**Addendum No. 2
January 20, 2023**

Project: Baltic High School Addition
Baltic, South Dakota
Arch Project No. 2957

Architect: Architecture Incorporated

ROOF FRAMING HIGH- AREA F
1/8" = 1'-0"

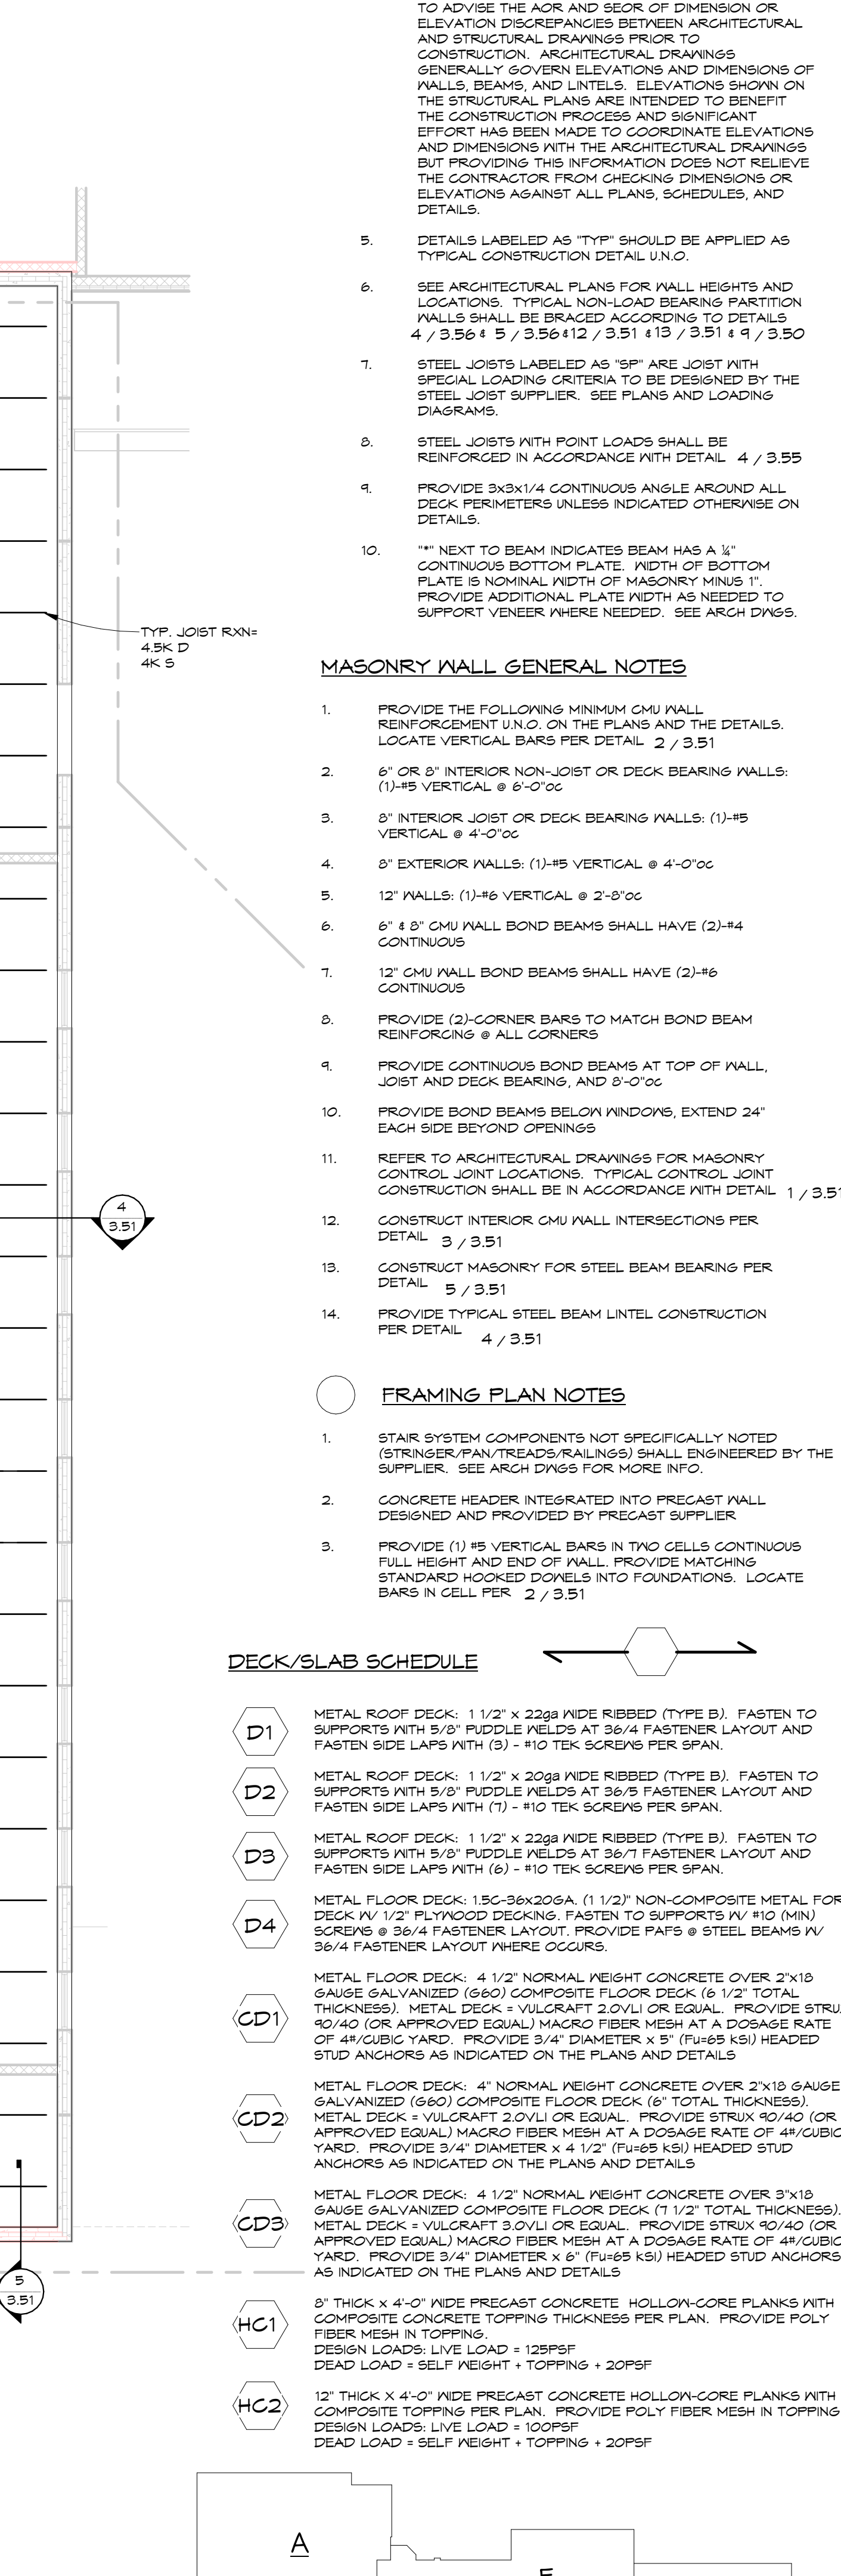
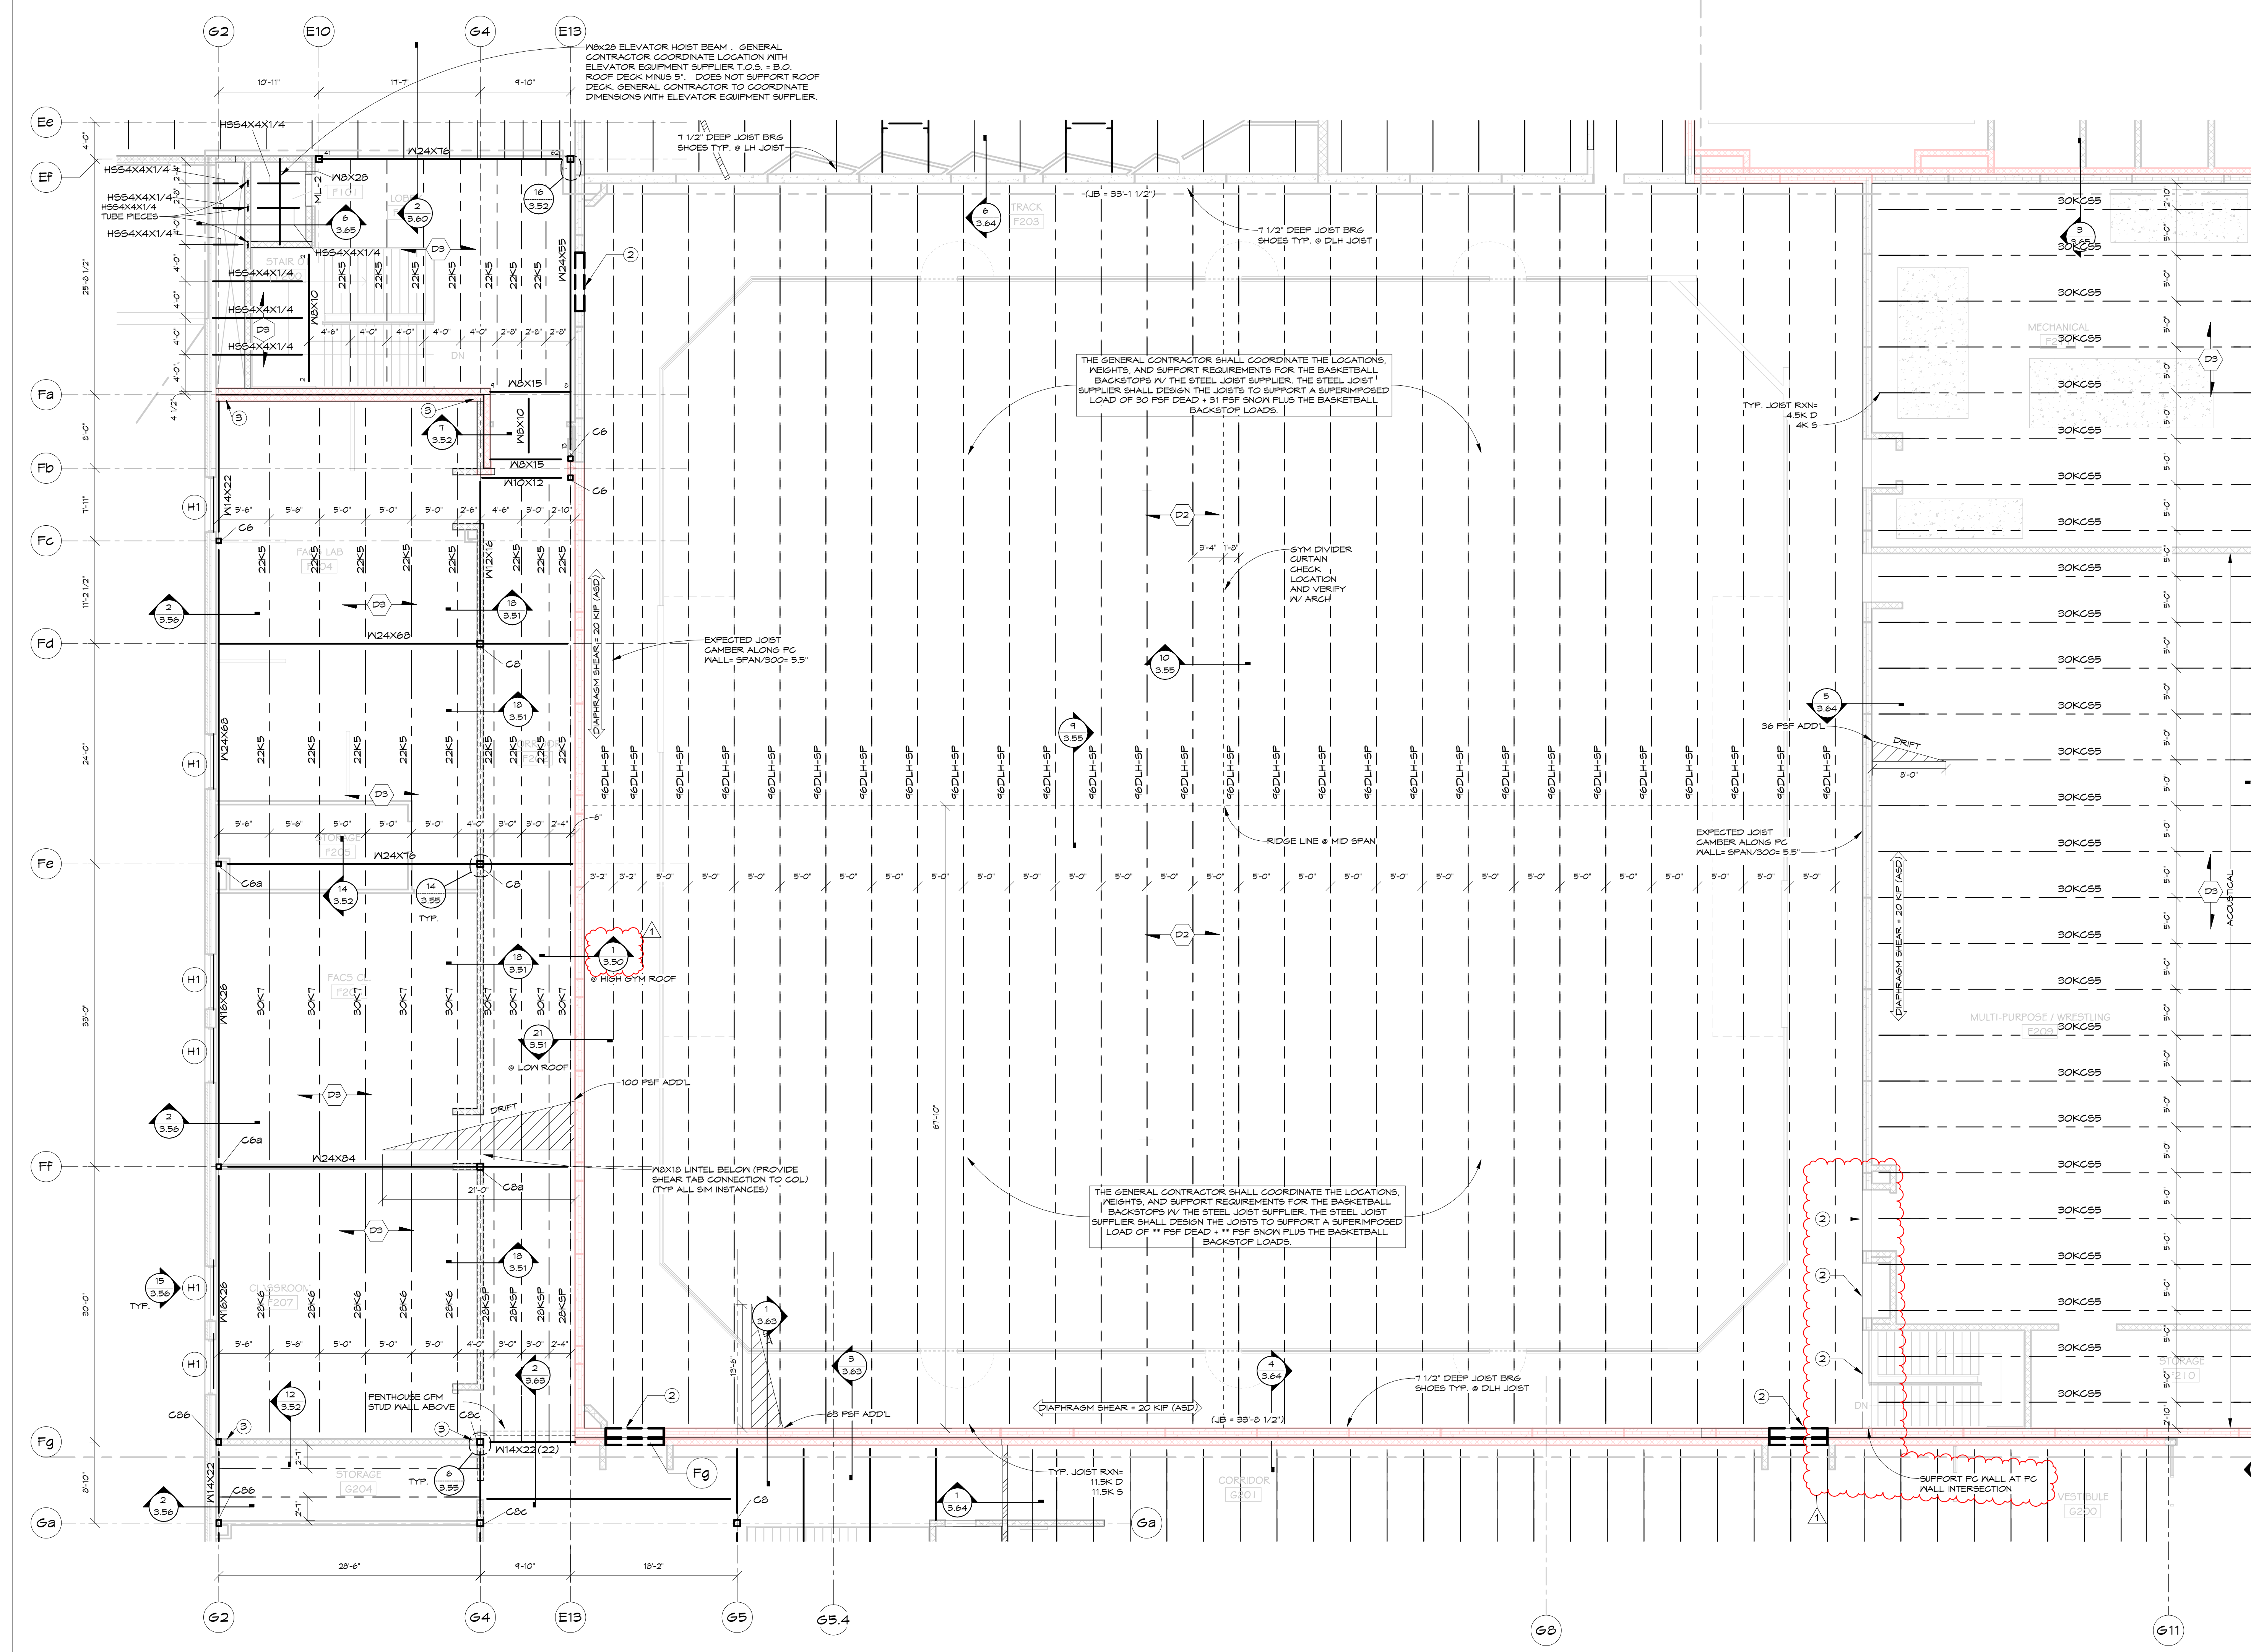
- a) Change section cut reference 5/3.51 to 1/3.50 found along gridline E13 at west precast wall of GYMNASIUM as indicated per revised structural drawing Sheet 3.20-3F.
- b) Modify precast wall openings at southwest corner of GYMNASIUM per clouded area on revised structural drawing Sheet 3.20-3F.
- c) Provide masonry bond beam lintels over door opening F202.
- d) Reference revised drawing Sheet 3.20-3F, revision dated 1-20-23, attached to the end of this addendum for structural changes listed above.
